Examination of a proposed subdivision north of Legana

by W. R. Moore

Figure 1

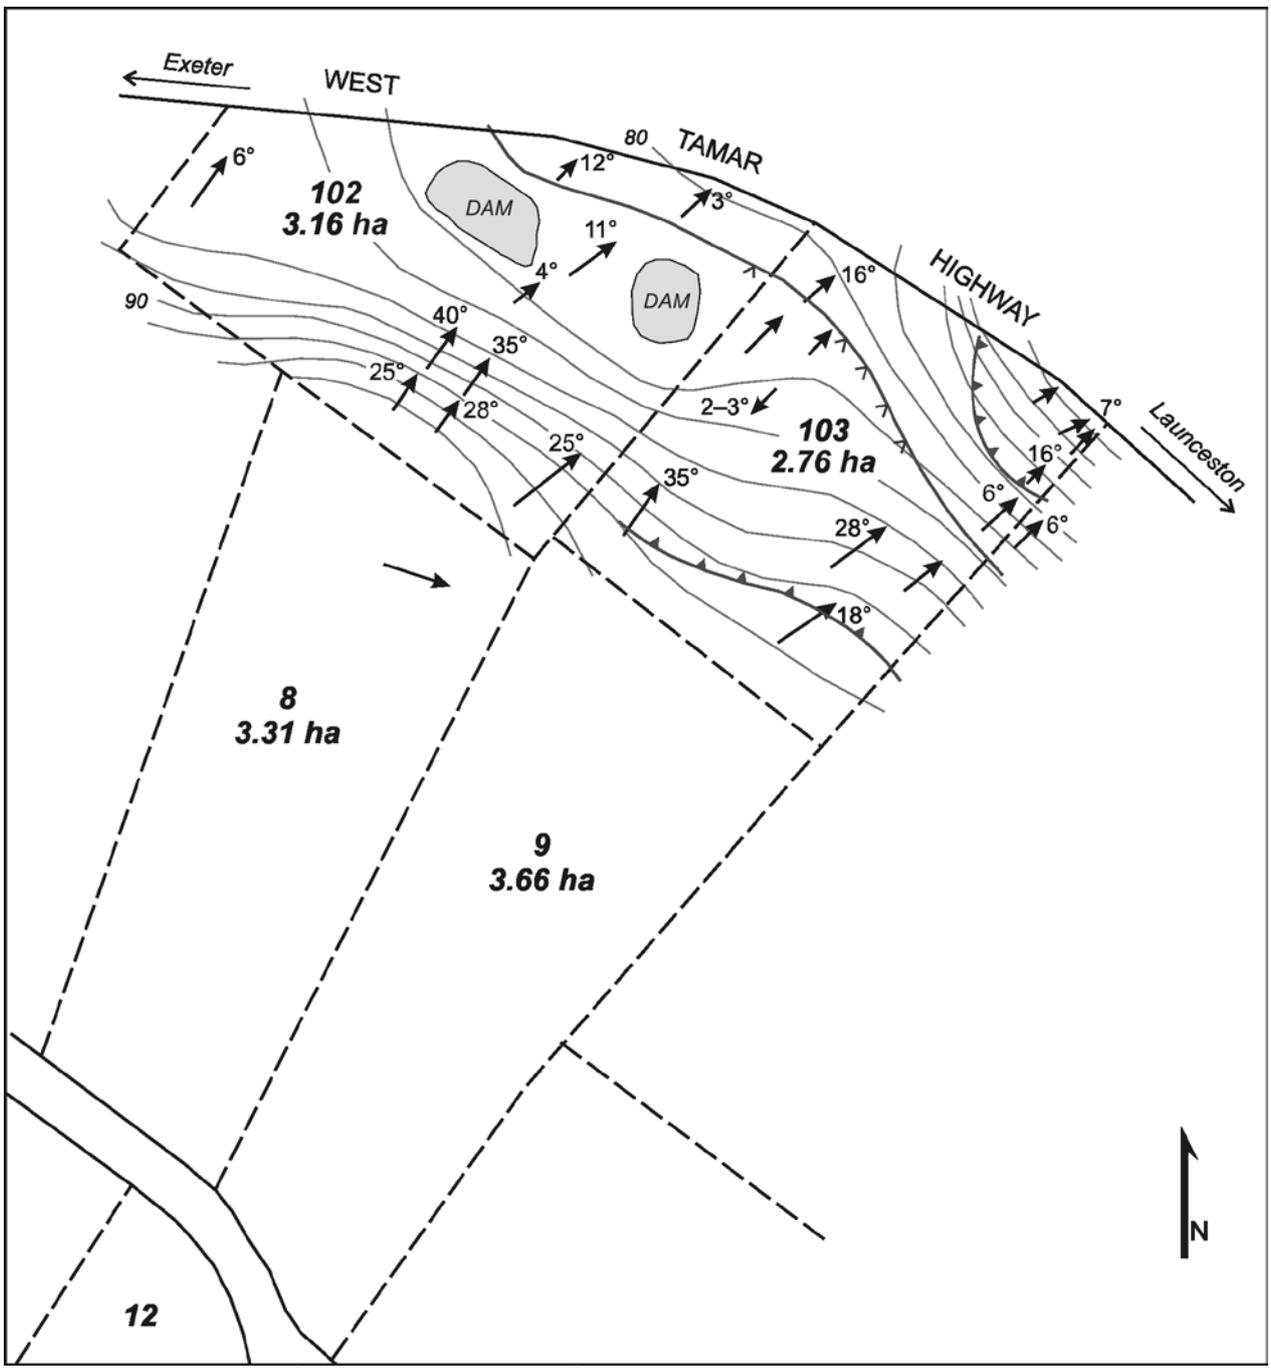
This low area has a complex topography (fig. 1). At the base of the cliffed section on block 103 is a flat low ridge with an inversion slope of 2–3° towards the base of the cliff. This ridge widens rapidly westwards through block 103 so that it covers most of the lower area of block 102. A swampy marshy area with a pond is present at the foot of the scarp and the inverted south-west slope on block 103. The inverted slope of the ridge flattens towards block 102 to give a broad ridge with a long sloping north-east limb of 4° to 6° degrees on the north-eastern boundary of block 102. The north-eastern slopes of this ridge are long and vary from 6° at the western boundary of block 103 to 11° on block 102. The north-eastern limb of the ridge ends by a short steep slope of 12–16° which near the West Tamar Highway flattens to 3°–6° to form a narrow flat area along the northern boundary of the blocks. At the north-eastern corner of block 103 is a small structure that appears to be an old parasitic landslide with a semi-circular scarp of 16° which flattens to 7° near the highway. Along the north-west boundary is a marshy area, possibly one of the old filled dams.

From this limited surface inspection it appears that most of the low area of blocks 102 and 103 is the northern end of a very old and probably very large landslide which has moved to form the inverted slope at the base of the cliff on block 103. Further movement or steps in the original slip are likely to have formed the steep scarplet along the northern boundary of the blocks with a smaller parasitic slide developing at a later date on north-east corner of block 103.

As well as having only a limited area available for building and limited access, blocks 102 and 103 have a potential slope stability problem. To evaluate this potential instability will require more detailed mapping over a wider area than undertaken in the above reconnaissance survey, followed by trenching and probably drilling. With the West Tamar Highway adjoining these two blocks care will have to be exercised so that any future increase in the amount of groundwater through septic tanks and stormwater soakage pits does not disturb this highway as has occurred north of the subdivision at Bradys Lookout.

Before any further slope stability investigation is undertaken it appears that decisions concerning access, available space and location of any future houses and limiting the soakage of septic tanks etc. away from the road should be made concerning blocks 102 and 103.
